POLLARD ENTITIES

# 3670 WOODLAND PARK AVENUE

JULY 27, 2023

# **01** LANDMARK RECAP

CONCEPT #1: ENGAGE

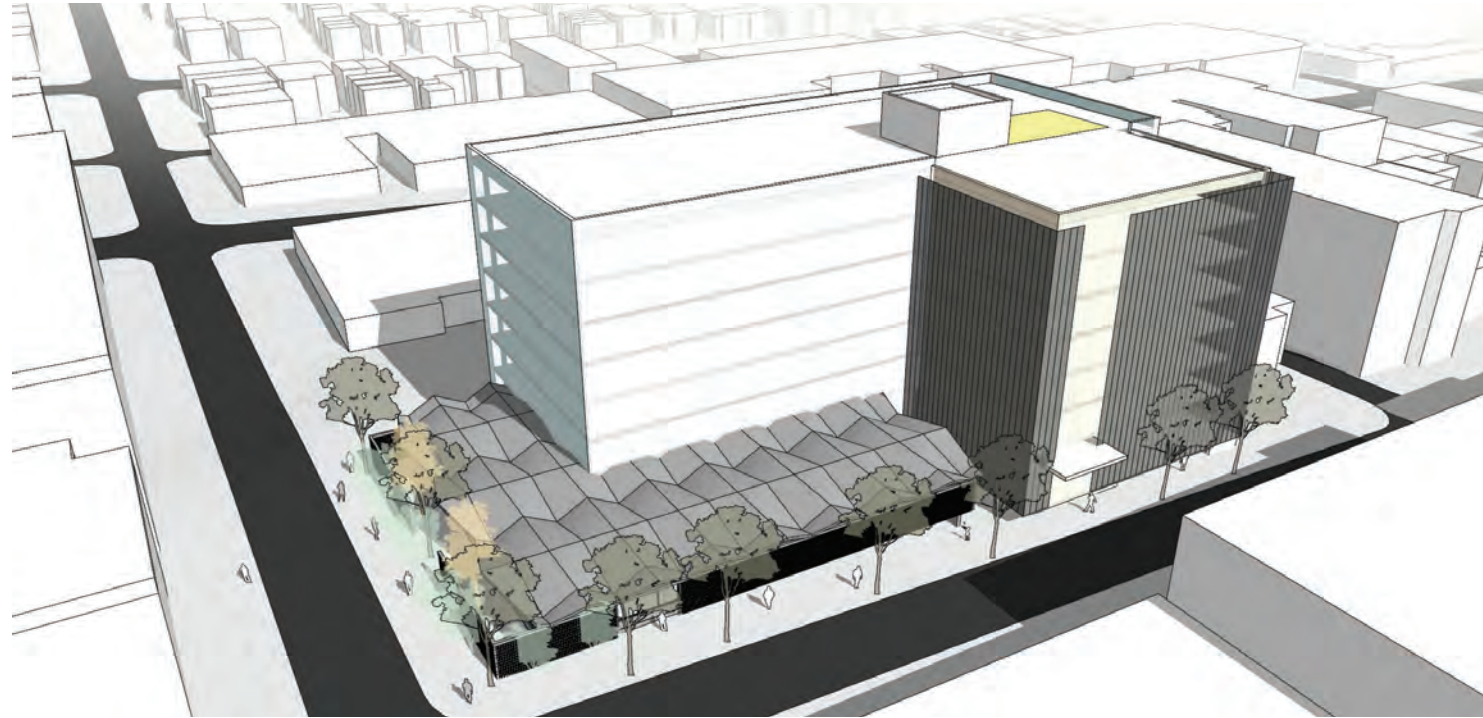
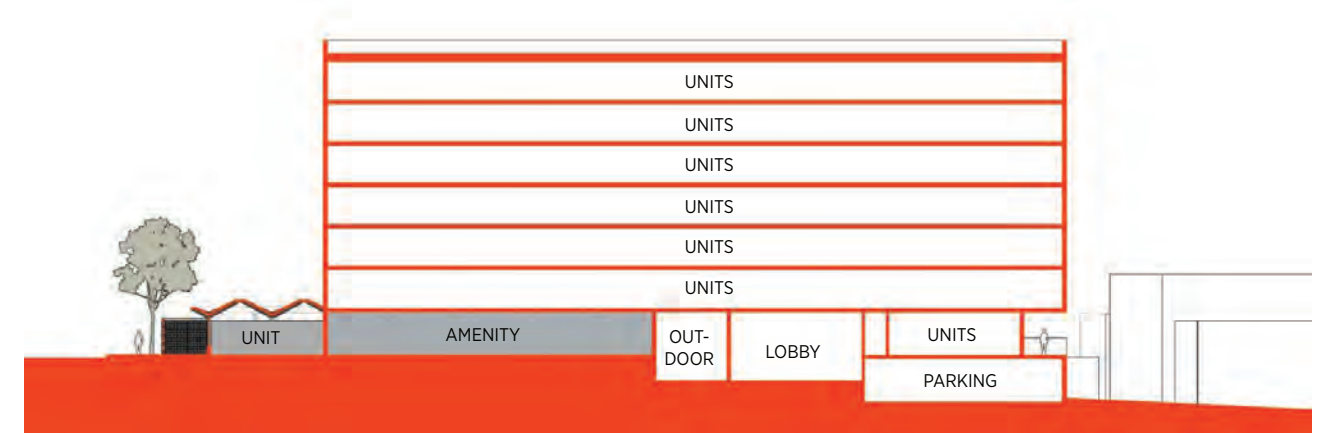
- Would have preserved the outer two structural bays of the landmark, while demolishing the interior to make way for the new development
- The ARC did not support this option and advocated maintaining the integrity of the landmark structure

CONCEPT #2: ROOM TO BREATHE

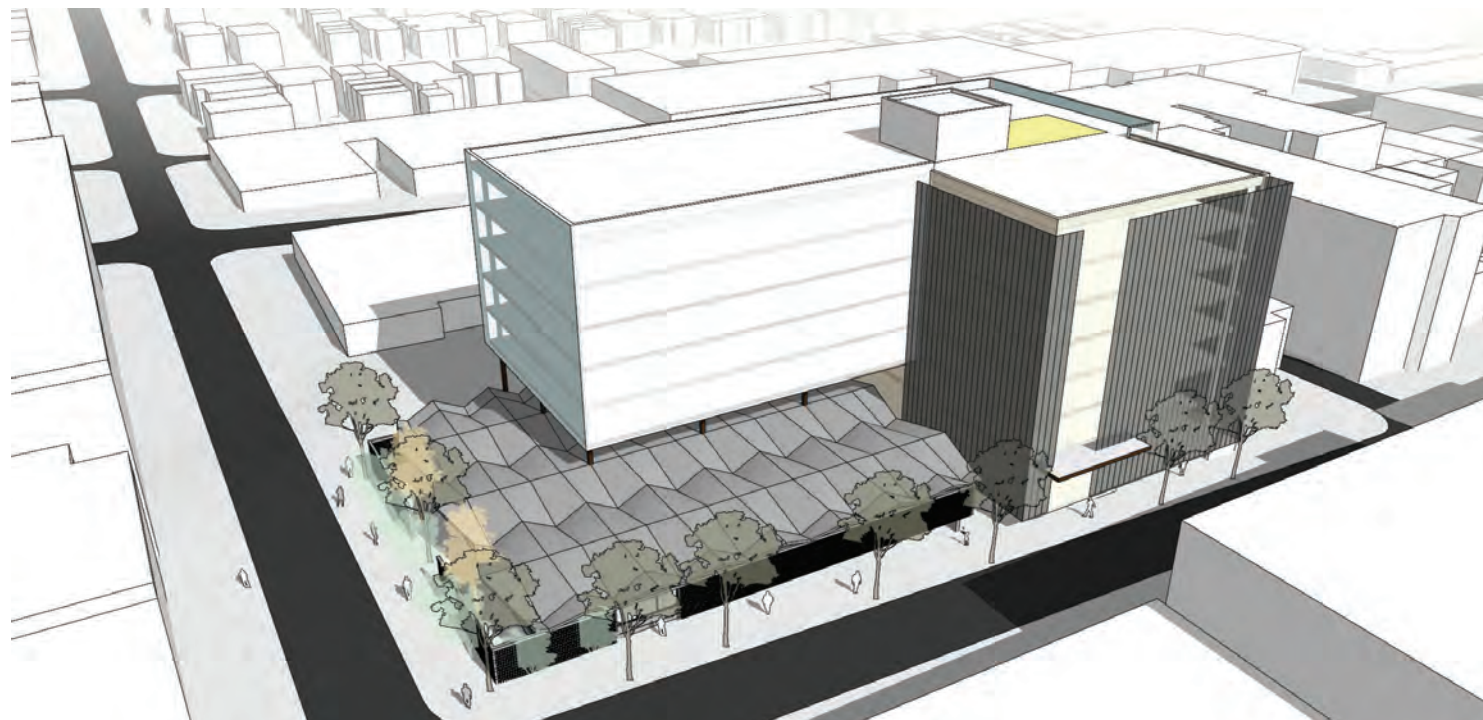
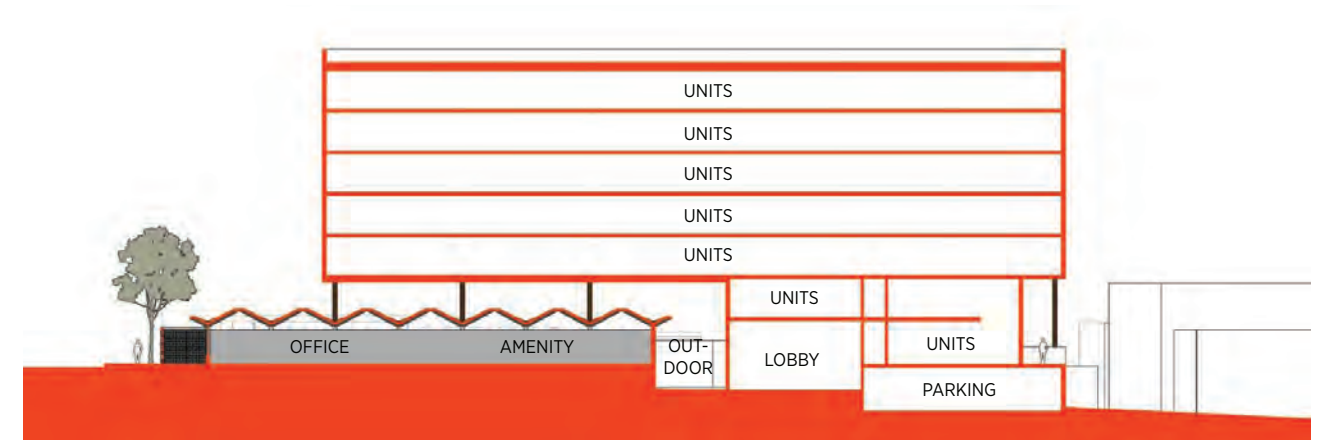
- Would have made use of the volume above the landmark, supporting the new development on a grid of piloti for a design that would have hovered over the iconic roofscape
- The ARC did not support this option commenting that it felt uncomfortable to build on top of the landmark building

CONCEPT #3: WALLFLOWER - FAVORED BY ARC

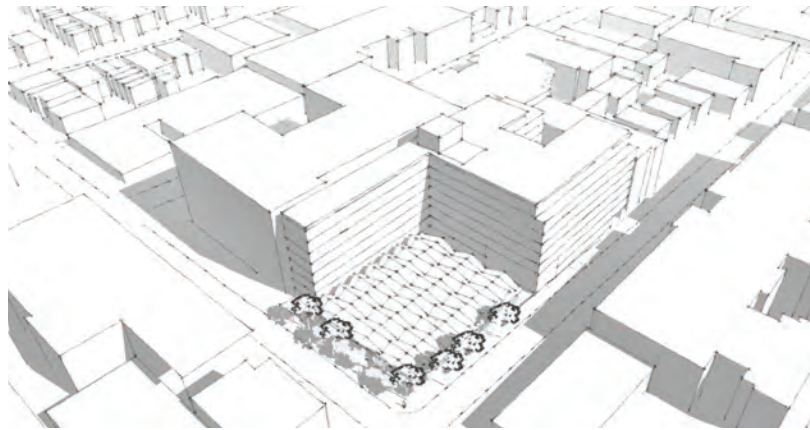
The board appreciated the design development based on board feedback from ARC briefing #1 to briefing #2

Board members were supportive of the narrow building proposed for the eastern portion of the site

The board supported the use of outdoor public space to connect old and new structures

Board members understood the justification for removing breezeblocks but were hesitant and want to see more specifics on how it would work

- 1 MASSING SHOULD SET BACK FROM THE LANDMARK TO RETAIN THE DISTINCTIVE FACADE AND ROOF FORMS
- 2 RETAIN EXISTING BREEZEBLOCK WALL WHERE POSSIBLE
- 3 ANY NEW DEVELOPMENT SHOULD BE CONSIDERED AS “BACKDROP” TO THE EXISTING STRUCTURE

# RESPONSE TO DRB GUIDANCE ON RESPONSE TO LANDMARK

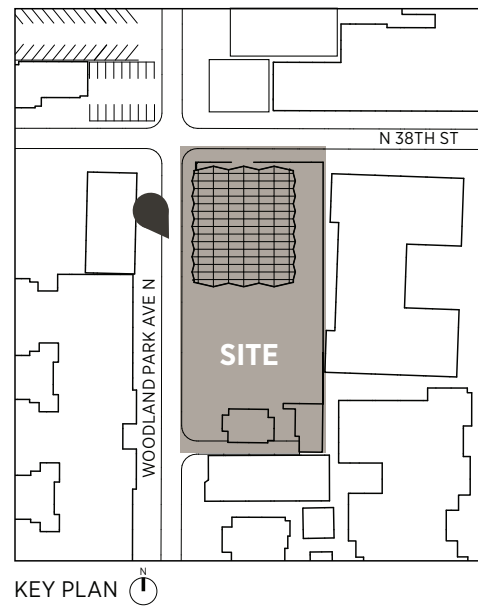
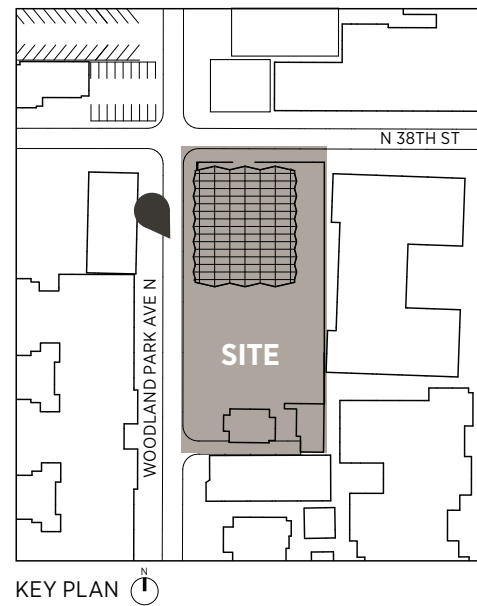
c. The Board noted that the proposed design was described in the presentation as a 'background' building that would allow the Landmark visual primacy and, echoing public comment, agreed that this was an appropriate strategy in response to context.

d. Echoing public comment, the Board provided guidance to explore simplifying the design in response to the Landmark, and to explore the development of horizontal compositional elements to deemphasize the 8-story height of the proposal and mitigate its scale.

The architectural expression of the proposed structure has been revised to produce a “quieter” aesthetic. Upright bands of color and surface plane changes that previously generated a feeling of verticality have been traded for a more consistent color scheme and fenestration arrangement that emphasizes horizontality. Along Woodland Park Ave, deep balconies previously organized in a dynamic, alternating pattern have been traded for a field of shallow Juliette balconies arrayed in a more stayed grid arrangement. Schematic elevations of all four sides of the primary structure as well as the townhouses has been provided.

**EDG #2** Whereas the architectural expression at EDG 1 emphasized verticality, the revised design conveys a more horizontal emphasis

# EXTERIOR MATERIALS

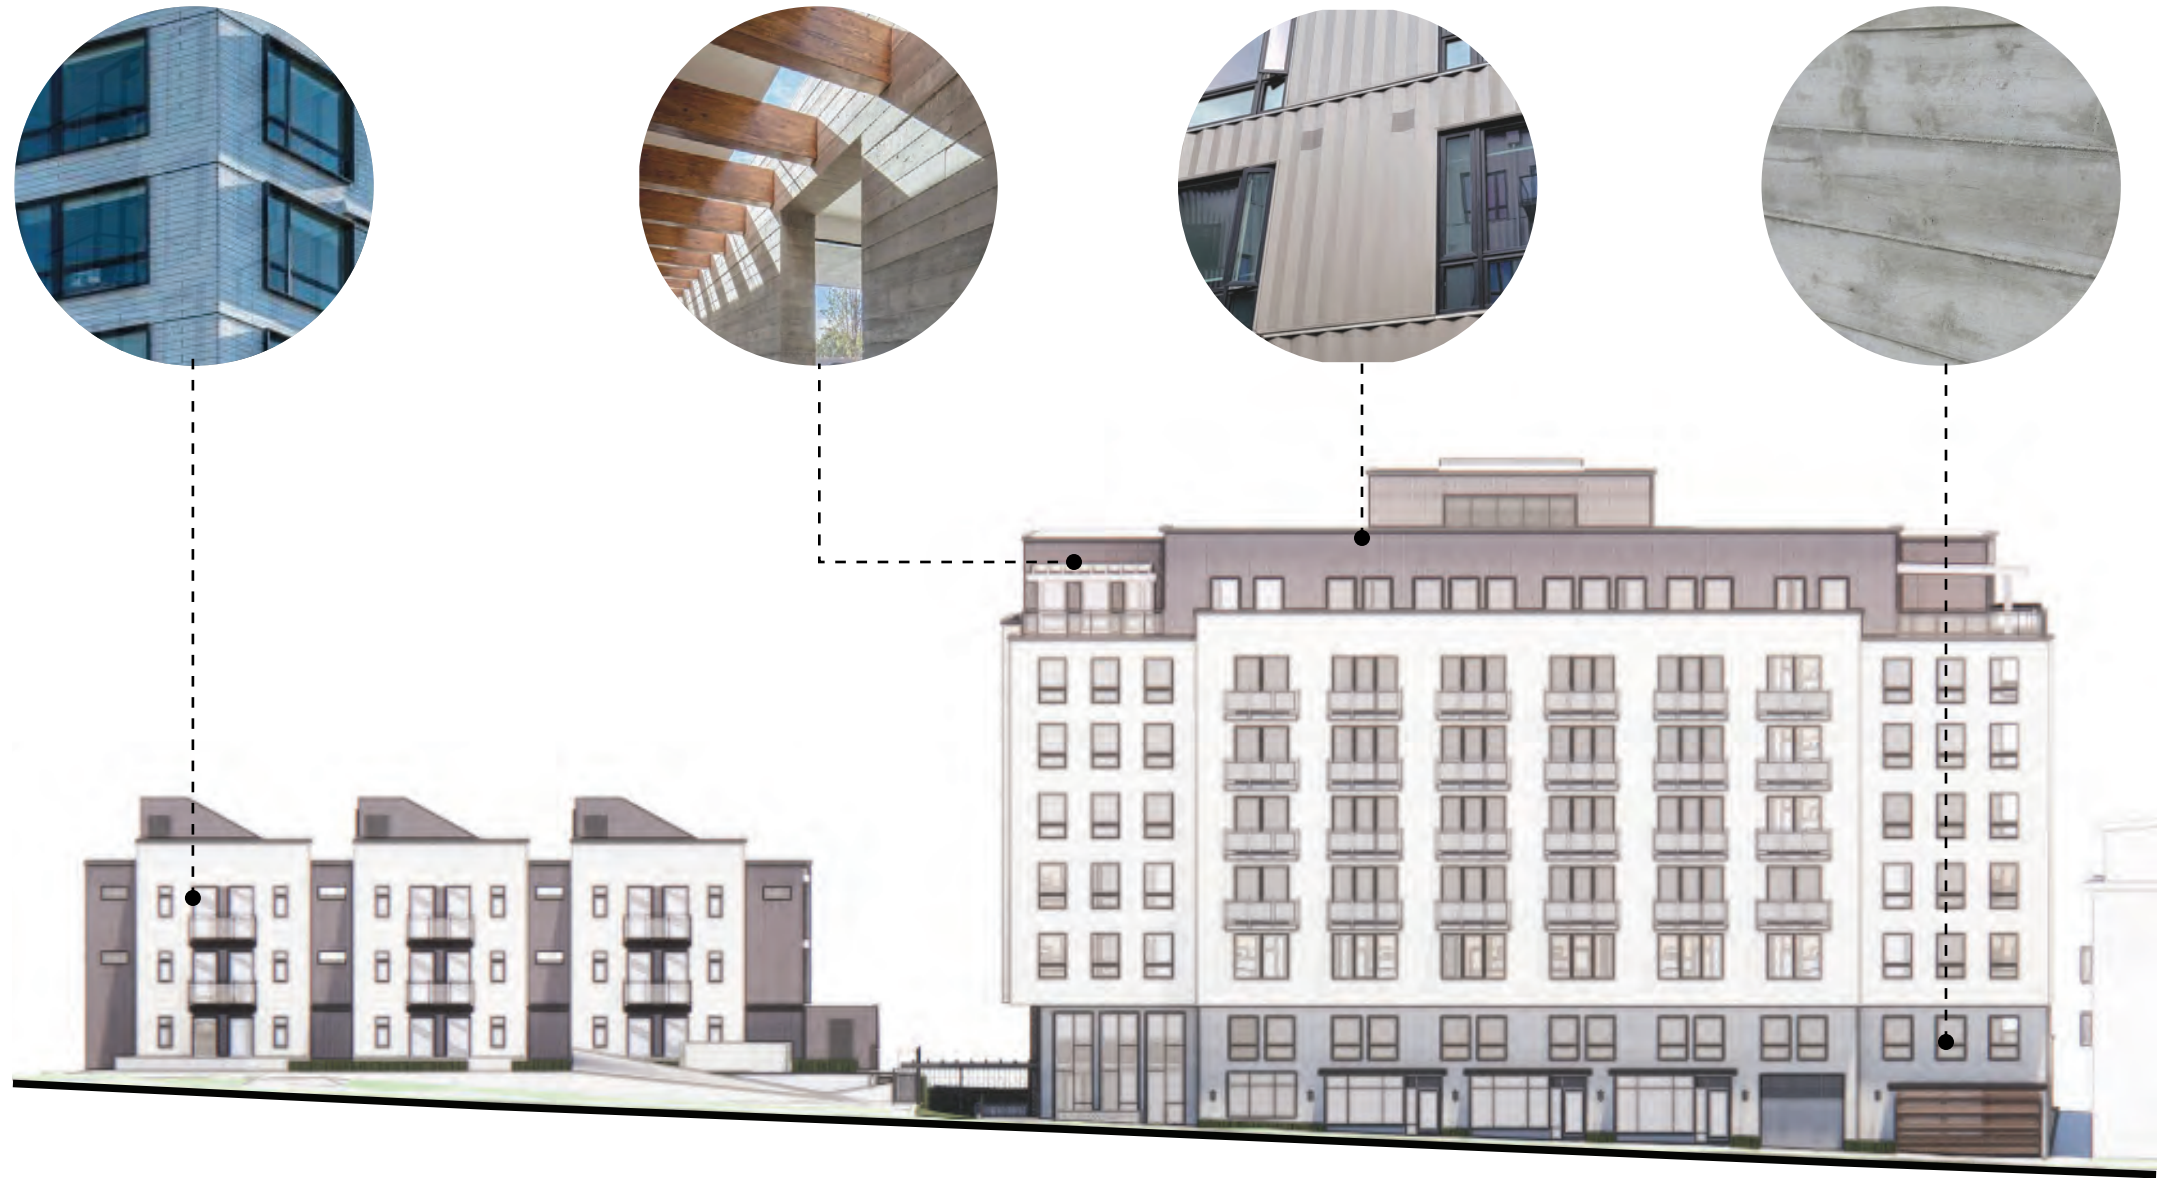
a. The Board supported the use of brick as a cladding material and echoing public comment provided guidance to develop a simple pallet of high quality materials in response to the strong material character of the adjacent Landmark.

The proposed structures will incorporate high quality, durable materials. The project team is considering the use of brick, metal panel, and upmarket fiber cement panels as options for the proposed project.
